**1 Products affected**

**2 Type of change**

Product Change Notification					PG09 Global Labeling Change		
owner	creation date	release date	released by	change order no	rev	page	D10-058-536
helblijo	22.09.2021	23.09.2021	barthro	2022706	B	1 of 2

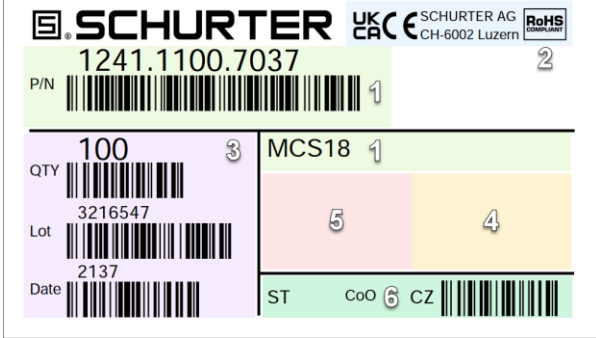
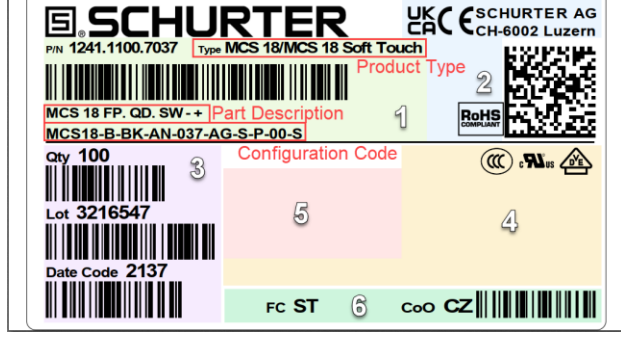
- Modified label
- Improved identification product configuration code on the label

**3 Detailed description of change**

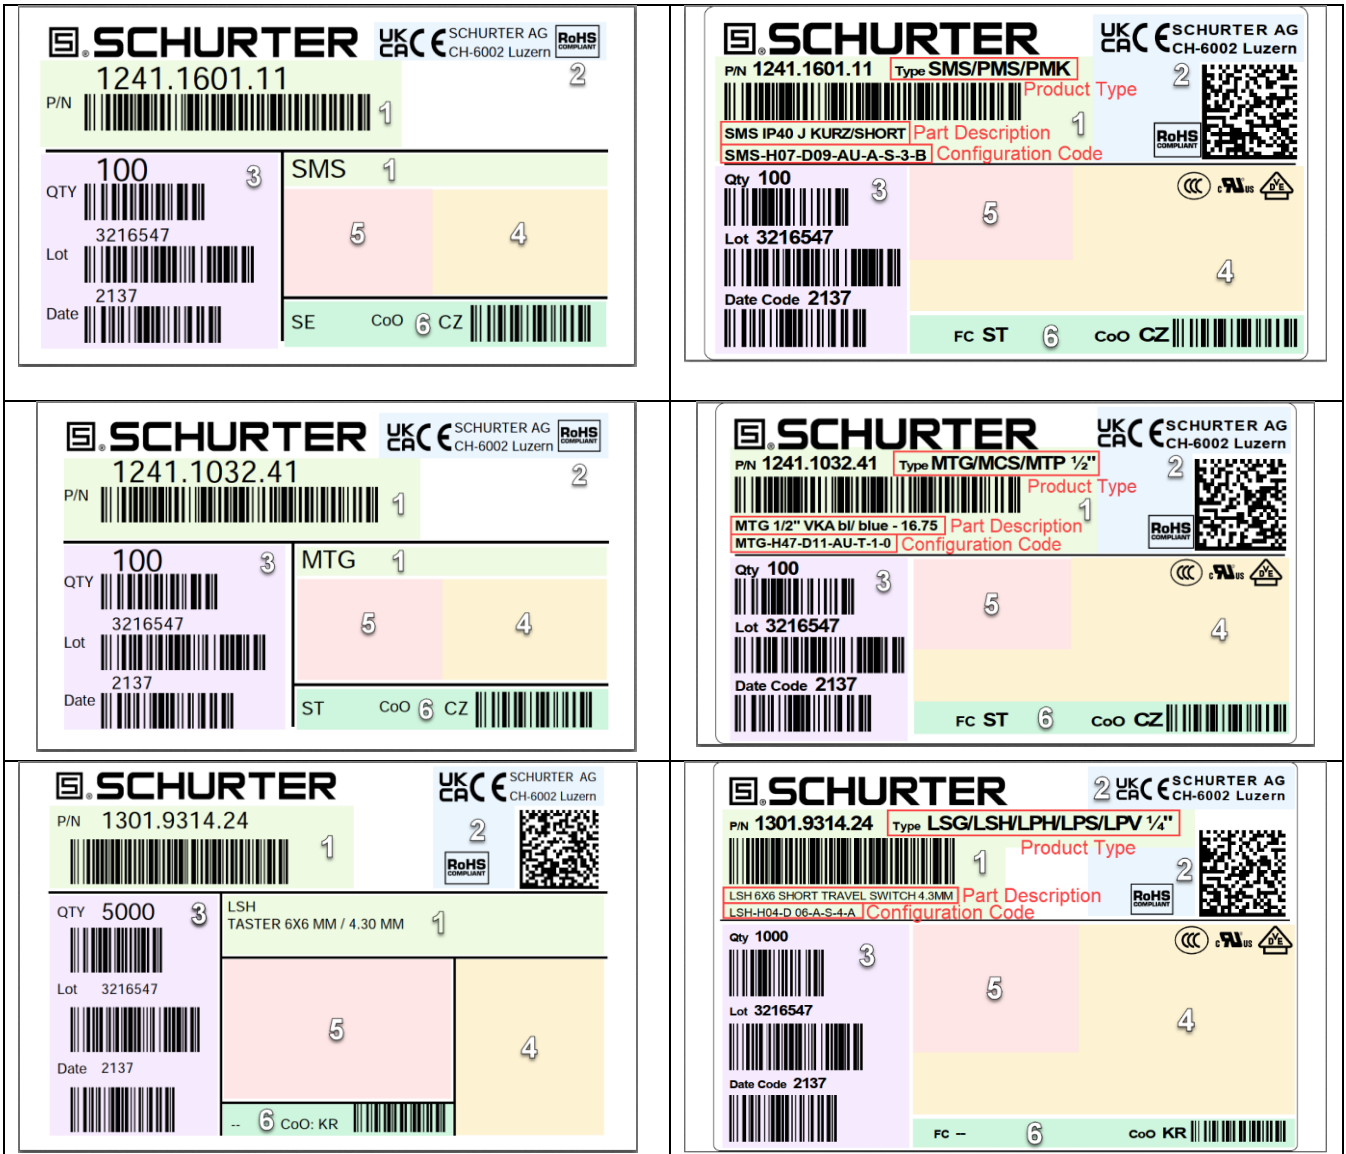
All product types listed in section 1 receive a new label layout.

To better visualize the changes, we have used colors and numbers to cluster information into the following sections (The colors and white numbers are not part of the new label layout):

<b>Product identification section:</b> To improve readability, we clustered all the information concerning product identification in this group. To increase clarity, we introduce our product configuration code into this area.	1
<b>Product conformity section:</b> Identical information was slightly rearranged.	2
<b>Product logistics section:</b> Label names changed. Information was slightly rearranged.	3
<b>Product approval section:</b> Identical information was slightly rearranged.	4
<b>Interruption ratings section:</b> Identical information was slightly rearranged.	5
<b>Origin information section:</b> Label for Factory Code was added. Information was slightly rearranged.	6

Old label	New label
 <p>The old label layout includes: P/N 1241.1100.7037 (1), SCHURTER AG CH-6002 Luzern (2), QTY 100 (3), Lot 3216547 (3), Date 2137 (3), MCS18 (1), ST (5), CoO CZ (6), and a barcode (4).</p>	 <p>The new label layout includes: P/N 1241.1100.7037 (1), Type MCS 18/MCS 18 Soft Touch (2), Product Type (2), MCS 18 FP. QD. SW. +  Part Description (1), Configuration Code (1), Qty 100 (3), Lot 3216547 (3), Date Code 2137 (3), FC ST (6), CoO CZ (6), and a barcode (4).</p>
